UNITED STATES PATENT AND TRADEMARK OFFICE

APPLICATION NO.	FILING DATE	FIRST NAMED INVENTOR	ATTORNEY DOCKET NO.	CONFIRMATION NO.
10/025,821	12/26/2001	Satoshi Shinada	Q67781	4266

Office Action Summary	Application No. 10/025,821	Applicant(s) SHINADA ET AL.	
	Examiner Leonard S Liang	Art Unit 2853

DETAILED ACTION

FIG. 1

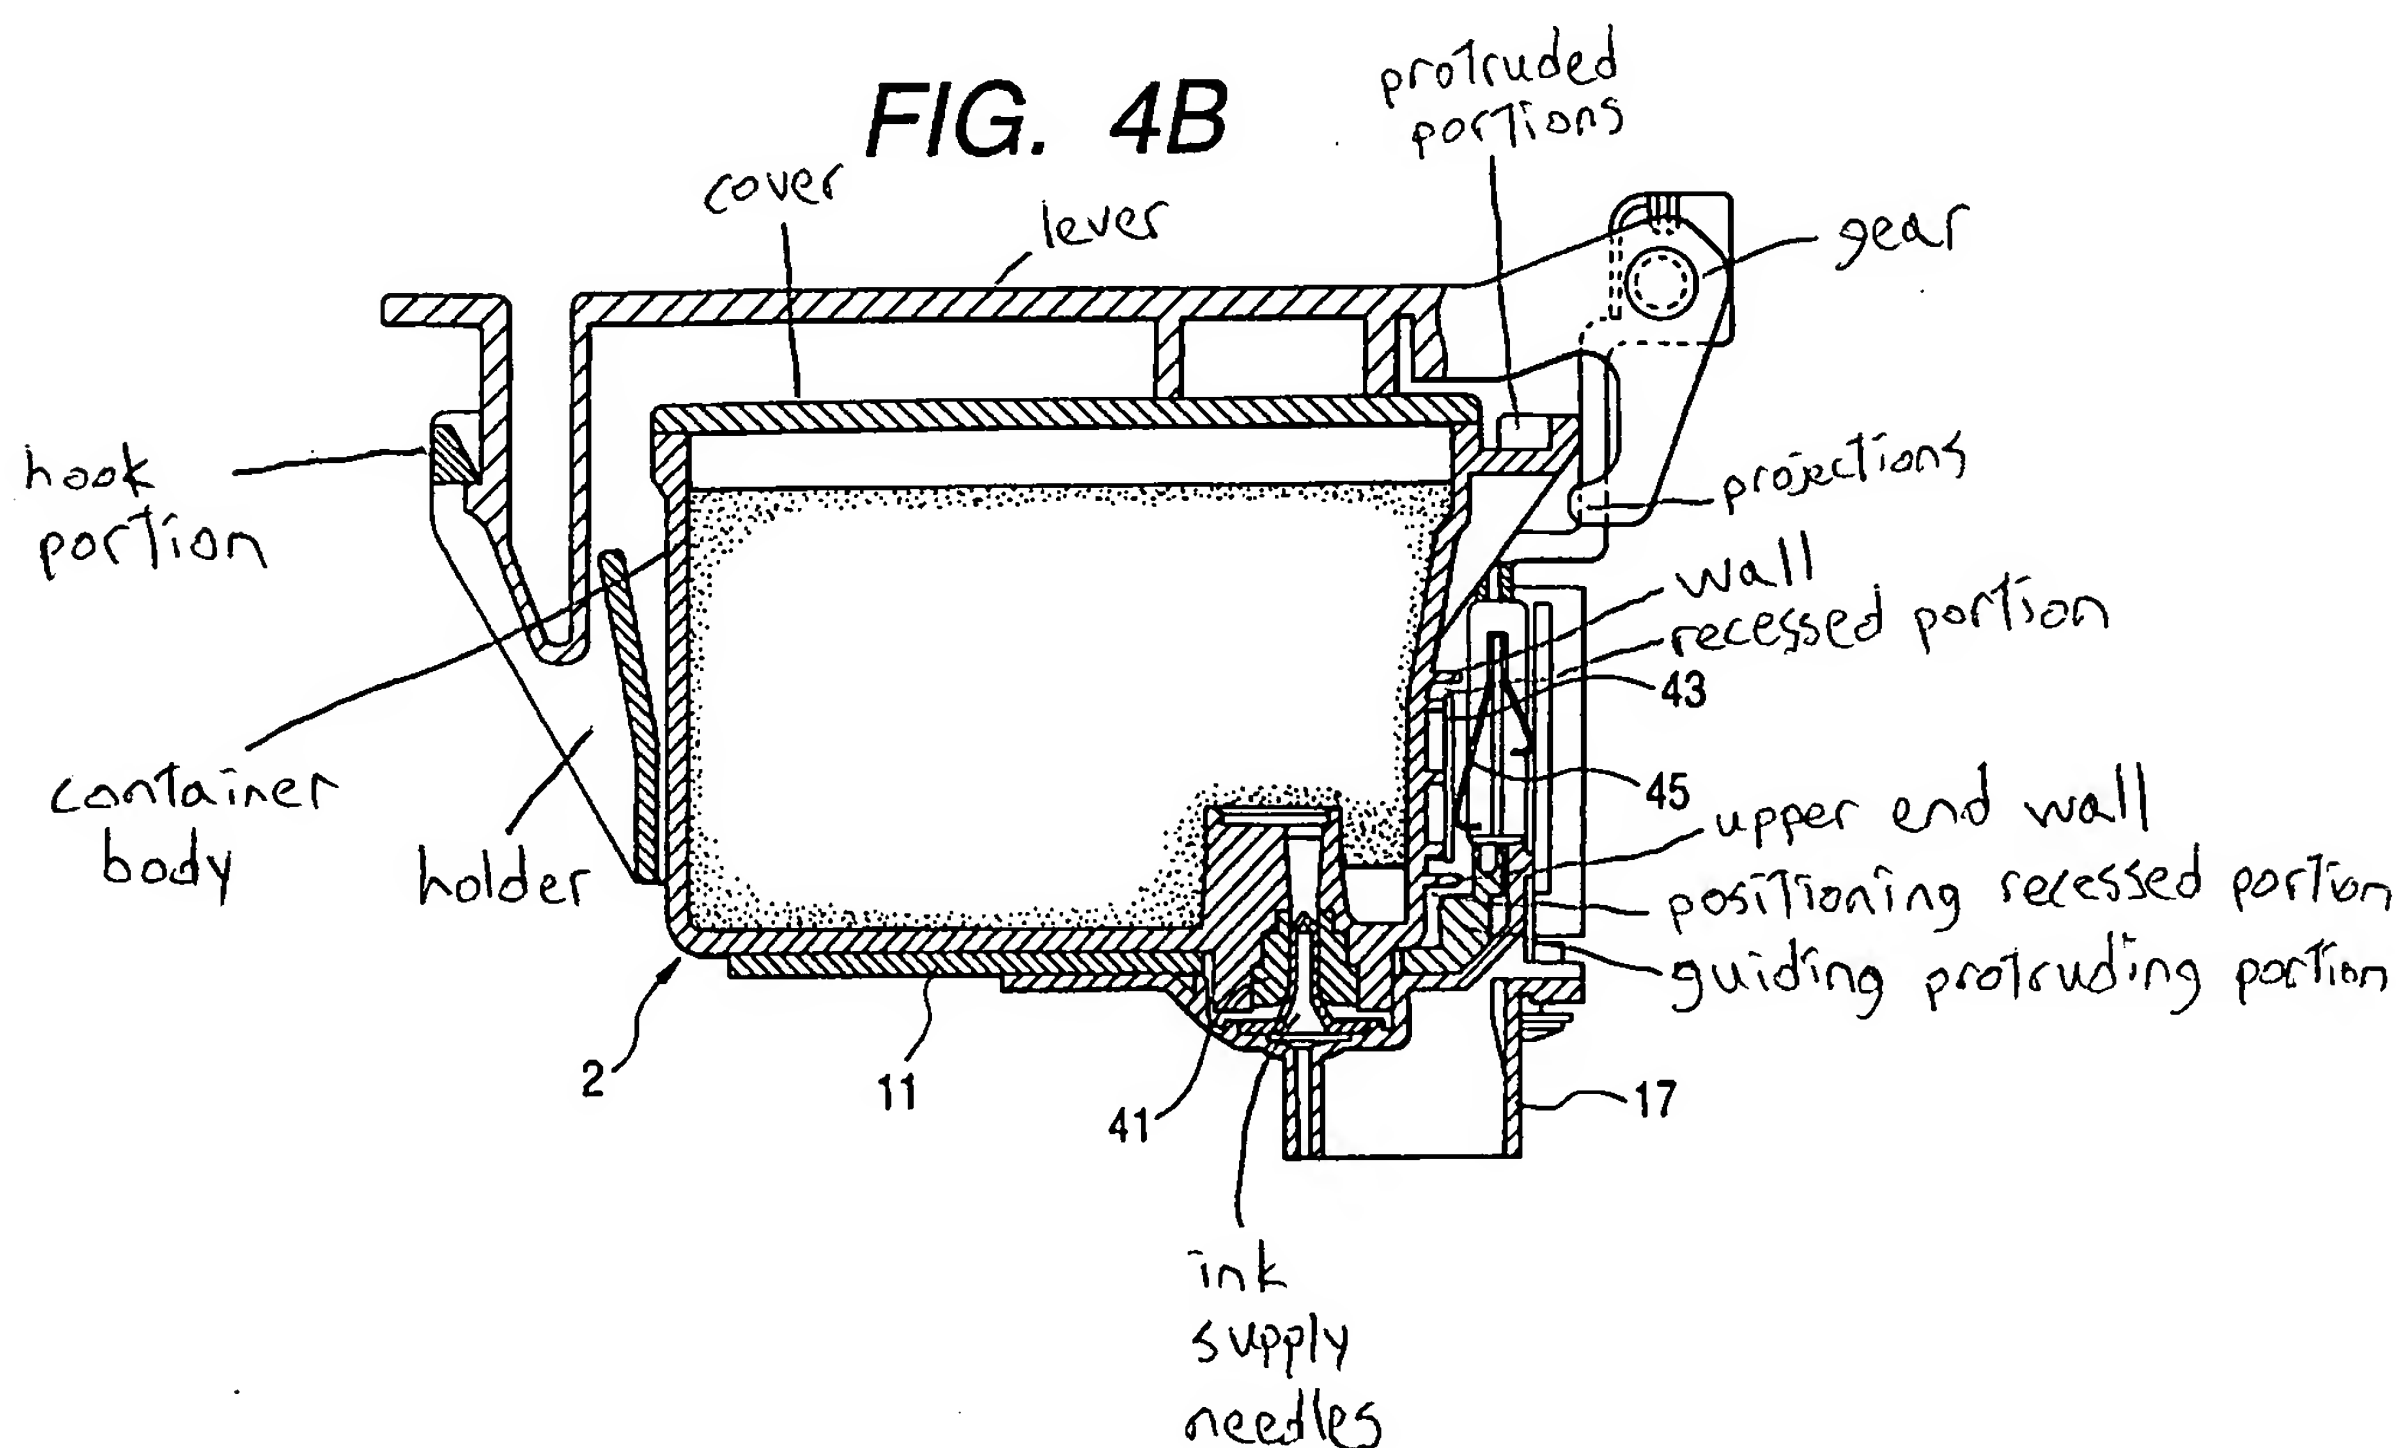
- {claim 1} An ink cartridge for an ink-jet recording apparatus (figure 1, references 1,2);

FIG. 4B

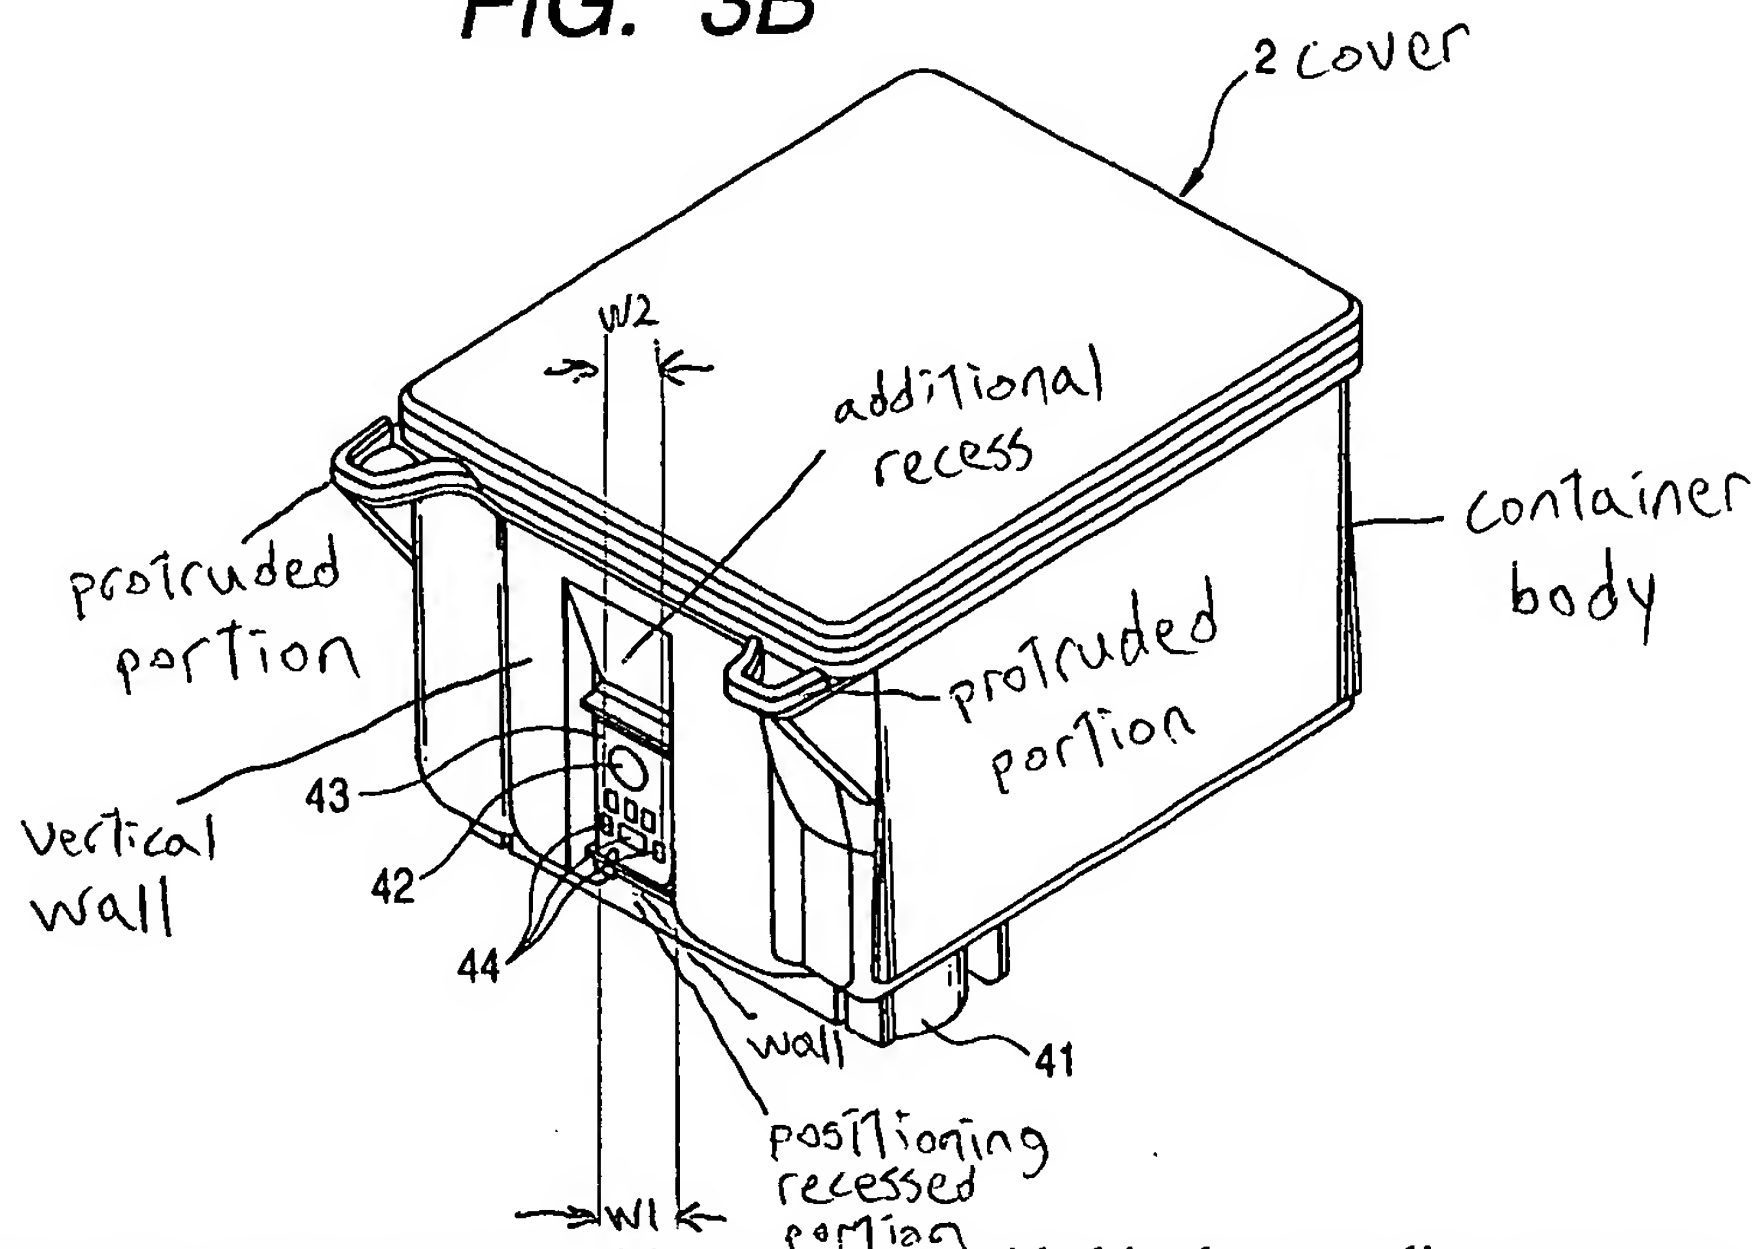
container body having an ink supply port (figure 4B, reference 41; container body drawn in);

- {claim 2} positioning system includes at least one recess that has an opening at a leading end thereof in an ink cartridge insertion direction, and that is engageable with the positioning member formed as a protrusion (figure 4B; positioning recessed portion, guiding protruding portion drawn in; it is seen that when the lever is lifted in a counter-clockwise direction around the gear, positioning recessed portion moves away from the guiding protruding portion; thus in the

alternate direction, the recess is engageable with the positioning member; thus the claim is inherent to the invention)

- {claim 4} recess has an upper end wall to be contacted with an upper end of the protrusion (figure 4B; upper end wall drawn in)
- {claim 5} the wall extends in parallel to a direction in which the electrodes are arranged (figure 3B; wall drawn in between contact electrodes and positioning recessed portion; it is seen that the wall extends in parallel to a direction in which the electrodes are arranged)

- {claim 10} circuit board having the electrodes is accommodated in a recessed portion formed in the container body (figure 4B, references 43, 45)

- {claim 11} the positioning recessed portion is formed at a position below a circuit board having the electrodes (figure 4B, references 43, positioning recessed portion)

- {claim 13} the container body has a recessed portion for accommodating a circuit board having the electrodes, and has a wall which defines the recessed portion and is brought into contact with a top surface of the protruding portion (figure 4B, reference 43, 45, upper end wall, positioning recessed portion, guiding protruding portion)

Fig. 5

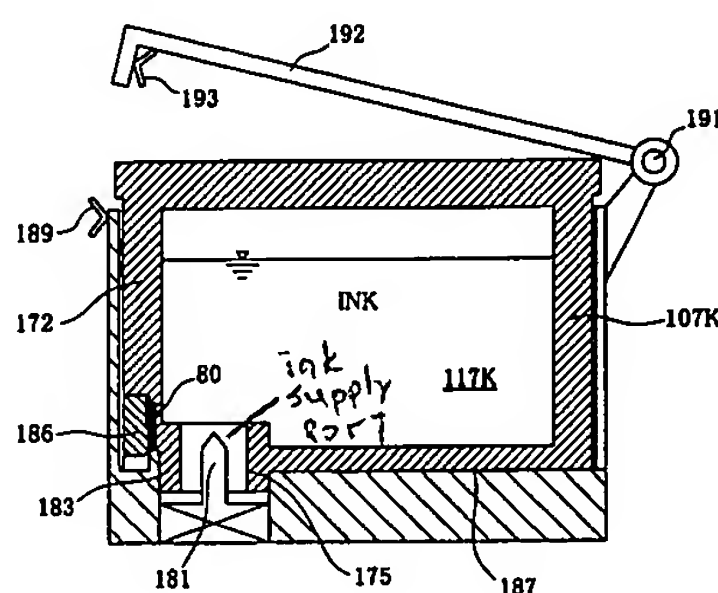
- {claim 1} An ink cartridge for an ink-jet recording apparatus (figure 5, reference 107K);

container body having an ink supply port (figure 5; reference 107K); a storage element disposed on the container body (figure 5, reference 80); electrodes to be contacted with contacts provided in the recording apparatus accommodating the container body therein (figure 4B, references 185, 186; column 12, lines 9-13);

Fig. 16

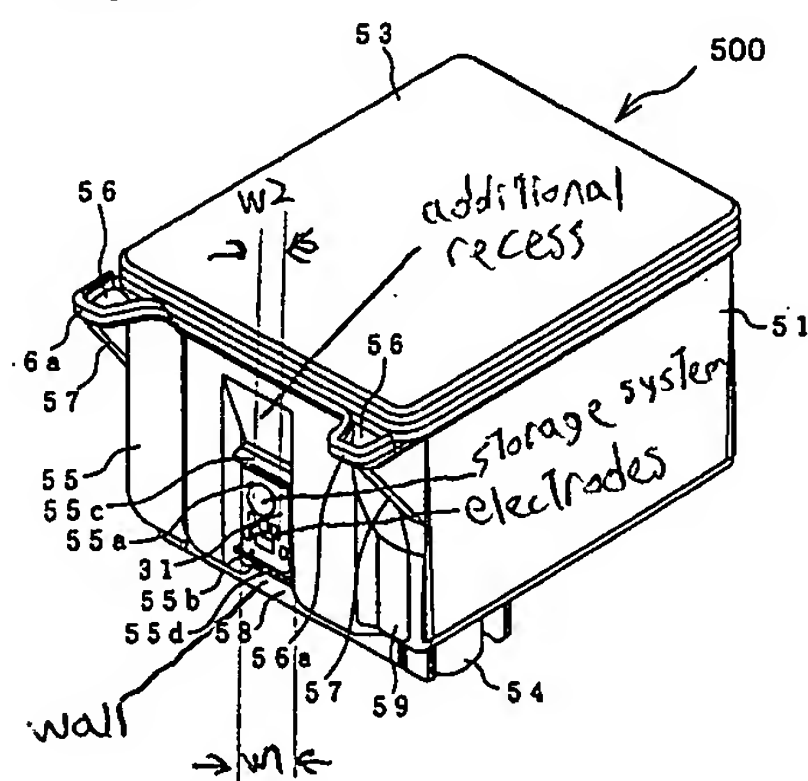
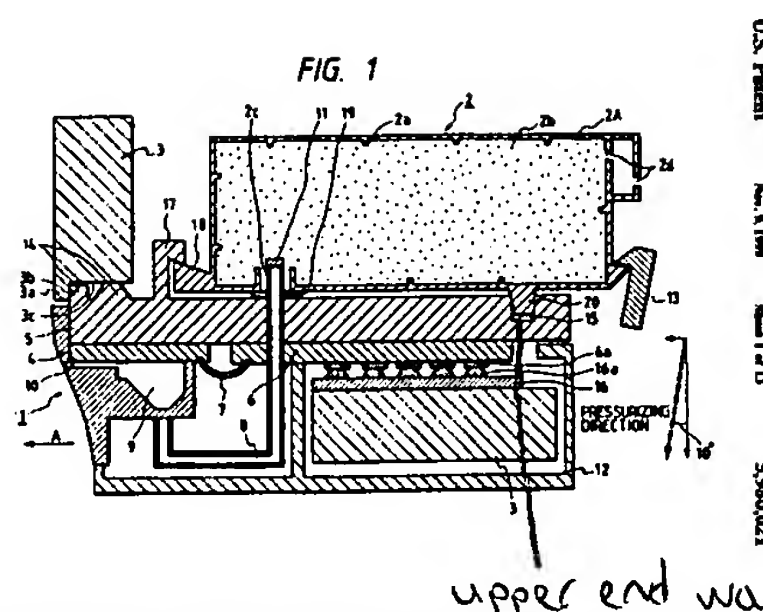
- {claim 3} the at least one recess includes a pair of recesses located opposite from each other with respect to the electrodes (figure 16, reference 58; additional recess drawn in)

- {claim 5} wall extends in parallel to a direction in which the electrodes are arranged (figure 16, reference 58; wall and electrodes drawn in; wall drawn in between electrodes and recess 58; it is seen that the wall extends in parallel to a direction in which the electrodes are arranged)
- {claim 6} a contact area between the wall and the positioning member is wider than a width of an area in which the electrodes are arranged (figure 16; the width of the area between the wall and the positioning member is [W1] and the width of the area in which the electrodes are arranged [W2] are drawn in; it is seen that $W1 > W2$)

- {claim 8} the storage element and the electrodes are mounted on a same flexible cable (figure 16; storage system and electrodes drawn in)
- {claim 9} an ink cartridge for an ink-jet recording apparatus, comprising: a container body having an ink supply port; electrodes; a storage element (as taught above)

- {claim 10} circuit board having the electrodes is accommodated in a recessed portion formed in the container body (figure 16, reference 31)
- {claim 11} positioning recessed portion (i.e. recess 58) is formed at a position below a circuit board having the electrodes (figure 16, references 31, 58, electrodes)

- {claim 13} the container body has a recessed portion for accommodating a circuit board having the electrodes (figure 16, references 58, wall, electrodes)

- {claim 16} the storage element is mounted on a circuit board (figure 16; storage element drawn in)
- {claim 17} a flexible cable is connected to a circuit board having the electrodes, and the storage element is connected to the electrodes through the flexible cable (figure 16; column 12, lines 9-13; column 23, lines 58-65)
